03 Bay Elevations

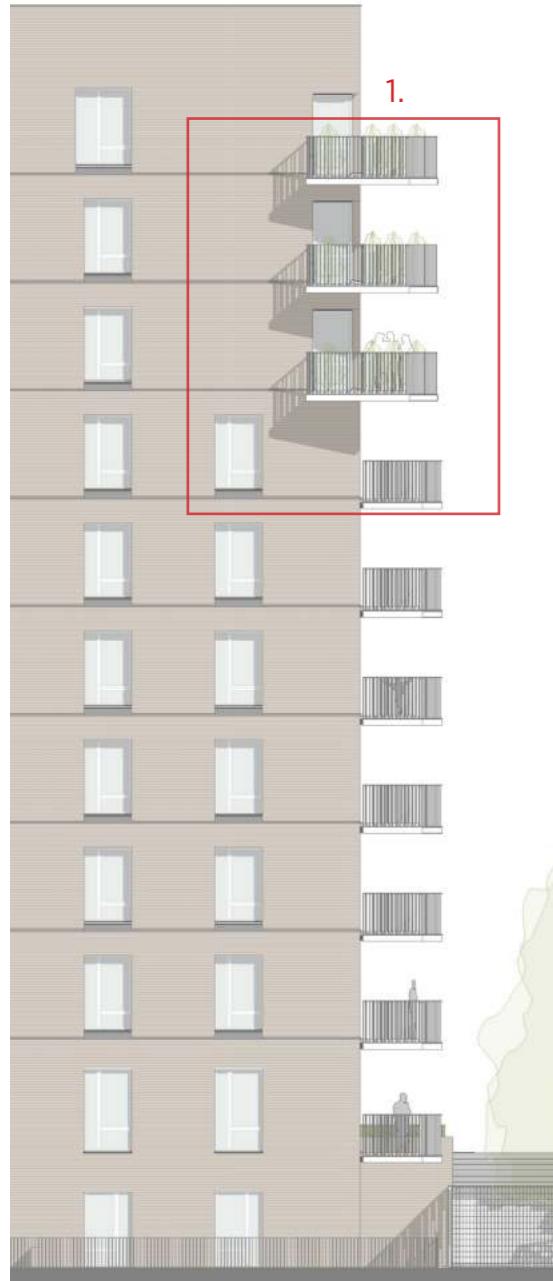
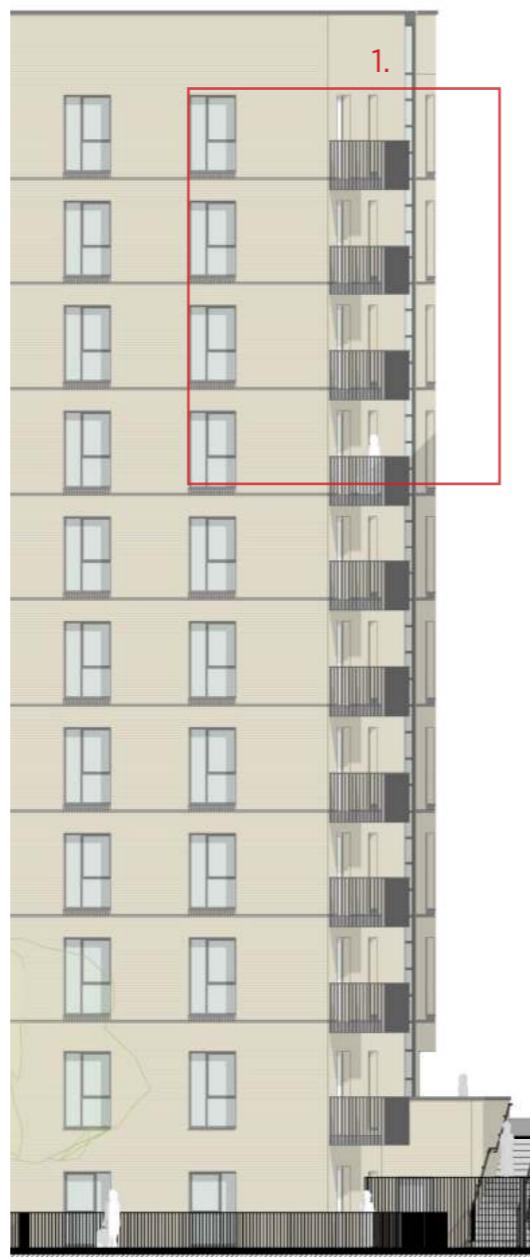
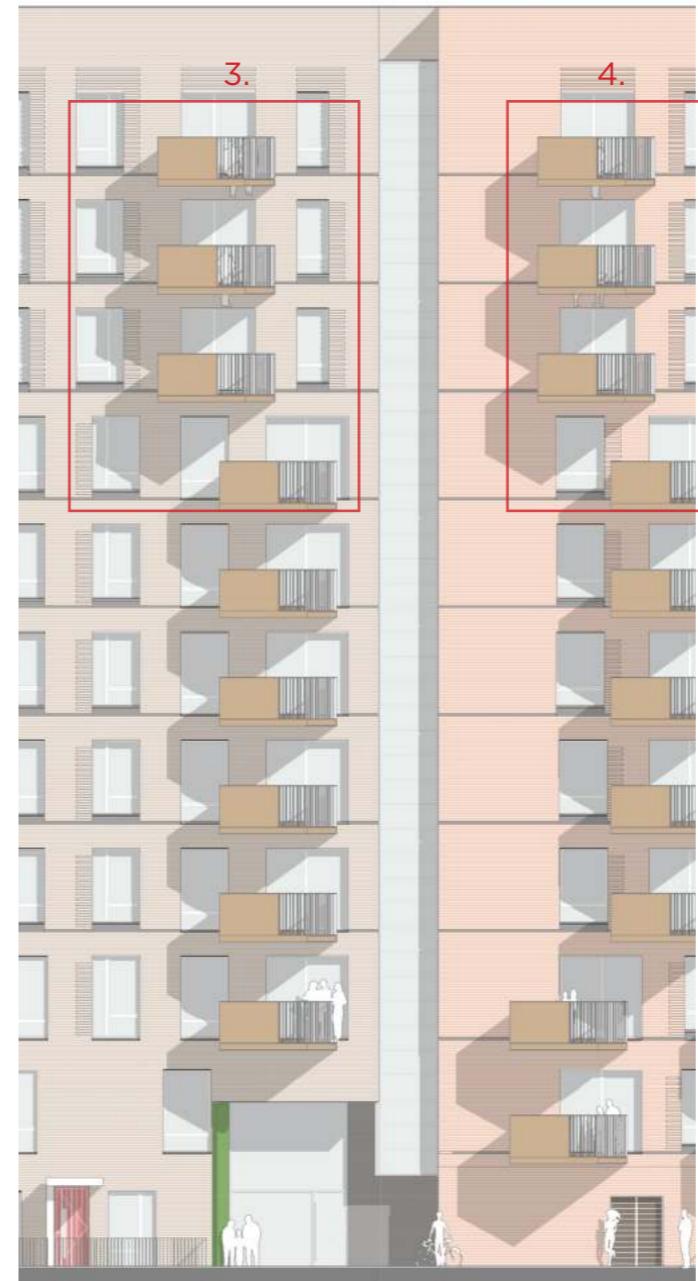
1. Rationalisation of balcony design as per previous phases
2. Windows omitted to suit developed stair/lift core design
3. Rationalisation of apartment stacking to facilitate drainage stacking / co-ordination
4. Window amended to ensure consistency between apartment type layouts
5. Window reduced to avoid internal clashes
6. Rationalisation / standardisation of balcony types
7. Balconies re-sized and linked to ensure compliance to London Plan area standards
8. Window type amended to match adjacent levels
9. Adjustment of architectural articulation
